Appendix D – FLM Consultation and Public Record  
D.1 – Notice of Opportunity for Early Consultation

## D.2 – FLM Consultation Feedback and Department Response

Figure 1. Visibility on most impaired days for Badlands, Theodore Roosevelt, and Wind Cave National Parks (2000-2020)

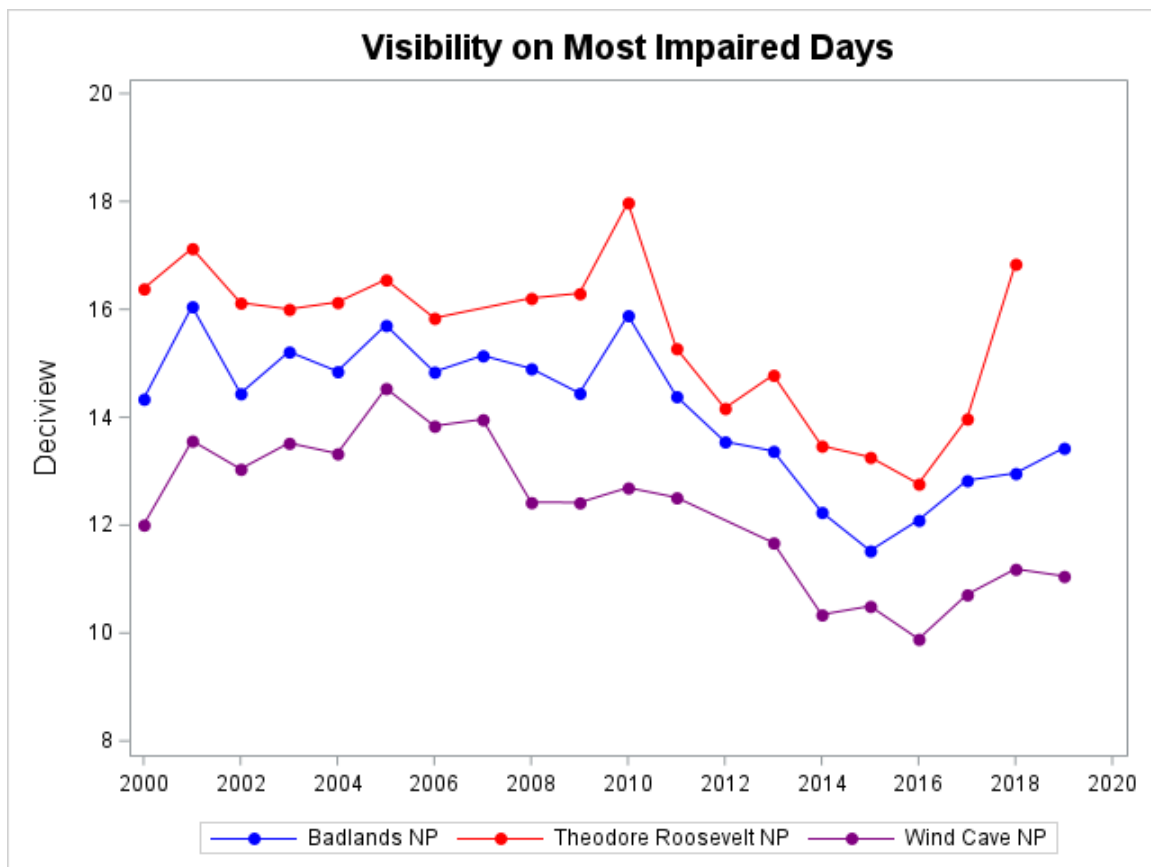
We also note that while trends in visibility conditions show improvement on the most impaired days since 2000, data since 2016 show an increase in haze at Theodore Roosevelt, Badlands, and Wind Cave National Parks (Figure 1). This highlights the need for continuing progress in reducing haze-causing emissions during this planning period.

Figure 12. CCS Unit #1 Calculated Monthly Avg. NO<sub>x</sub> Rate (January 2020–September 2021)

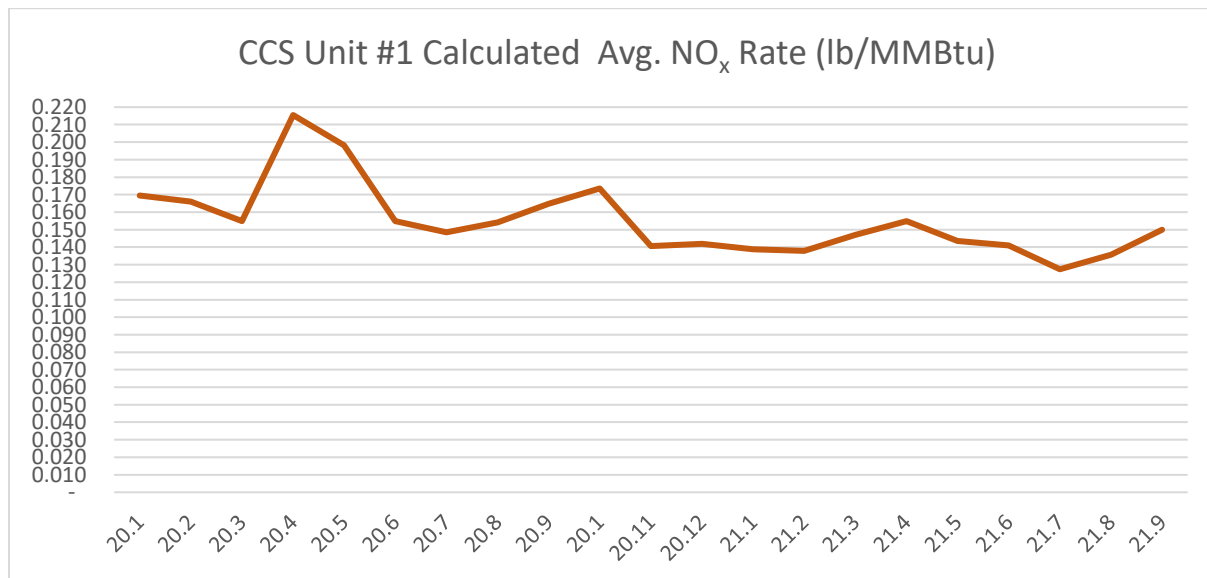
**NPS:** Unit 1 had expanded overfired air registers installed in the second quarter of 2020. We evaluated 21 months of CAMD NO<sub>x</sub> emissions data (January 2020–September 2021) and determined that the average emission rate was 0.146 lb/mmBtu (Figure 12).

Figure 17. MRYS Unit 2, Increasing SO<sub>2</sub> emission rate (2011–2020)

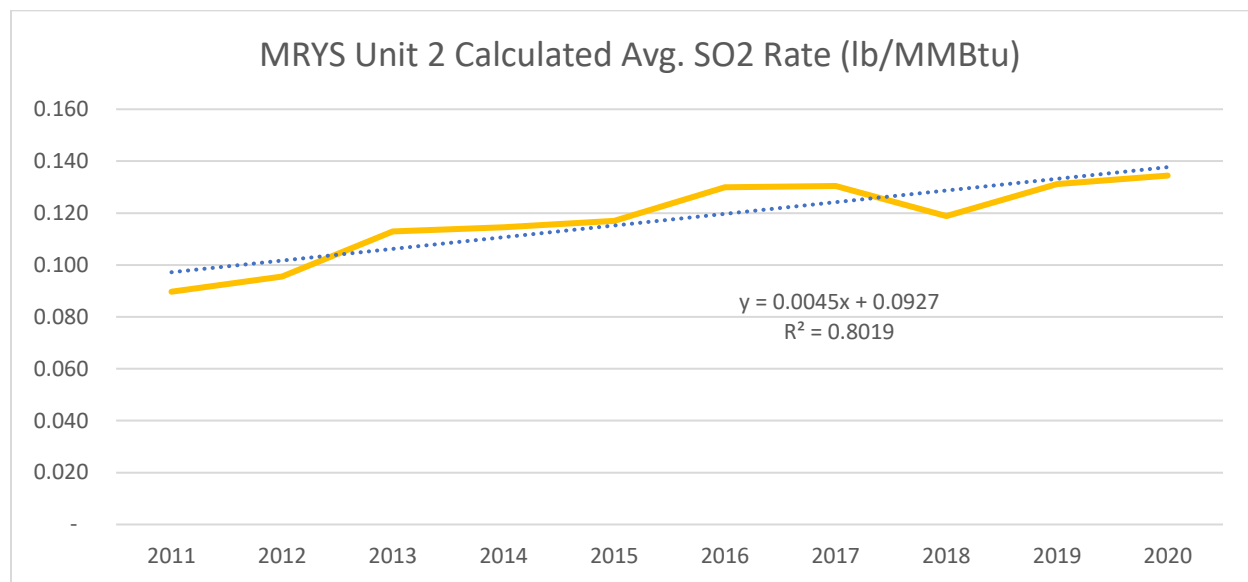
**NPS:** The chart below shows increasing SO<sub>2</sub> emission rates at Unit 2.

Figure 20. LOS Unit 1 SO<sub>2</sub> emission rates have been increasing recently (2014–2020)

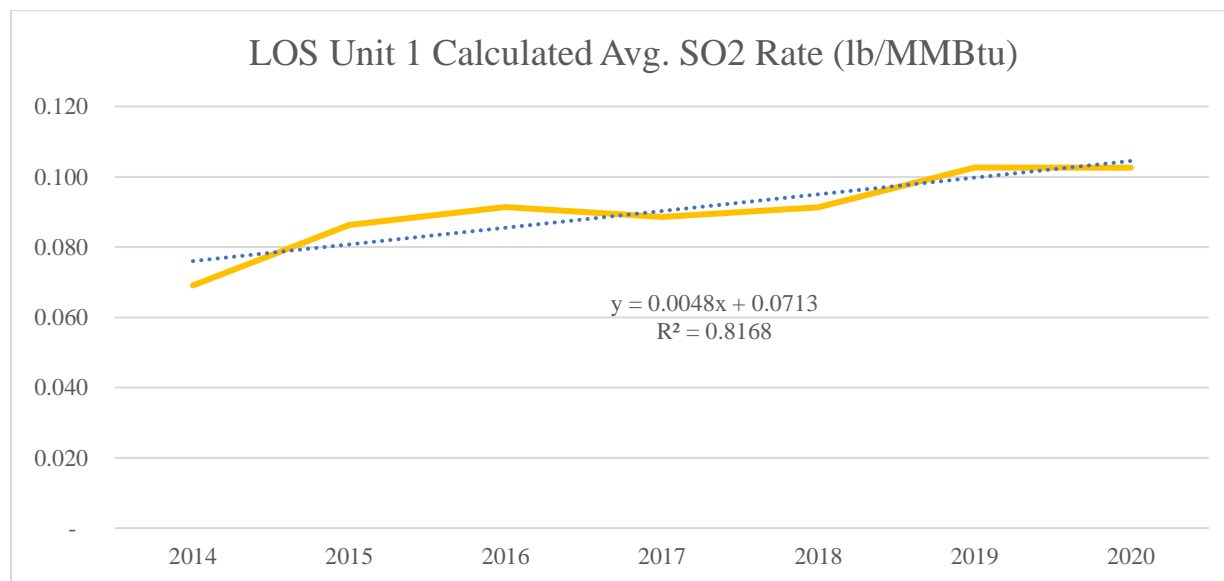
**NPS:** 2020 fuels data from the Energy Information Administration shows the average sulfur content of the lignite burned at LOS would result in uncontrolled SO<sub>2</sub> emissions of 2.08 lb/mmBtu.<sup>23</sup> CAMD data for LOS in 2020 showed that controlled SO<sub>2</sub> emissions averaged 0.103 lb/mmBtu at Unit 1 and 0.098 lb/mmBtu at Unit 2. However, Unit 1 emission rates have been increasing recently.

Figure 21: Active ND Oil and Gas Well Surface Locations Near Theodore Roosevelt NP.

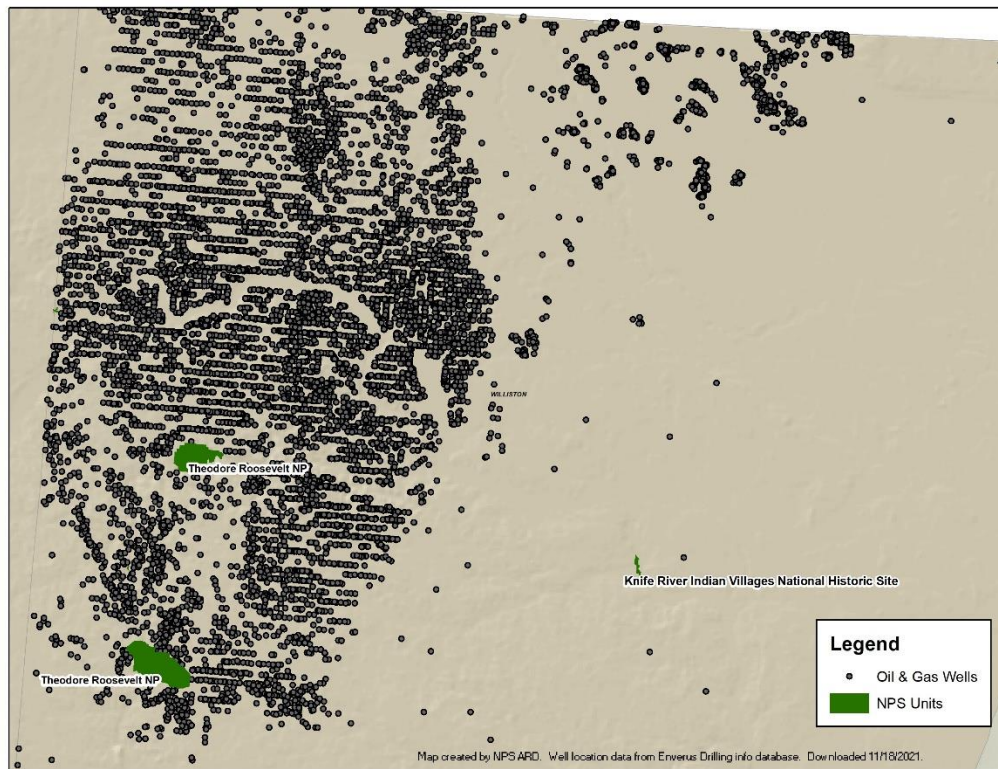
As of November 18, 2021, there were 22,166 active, drilled or permitted wells within the North Dakota portion of the Williston Basin.<sup>28</sup> As shown in Figure 21 below, the oil and gas development within the region surrounds Theodore Roosevelt NP.
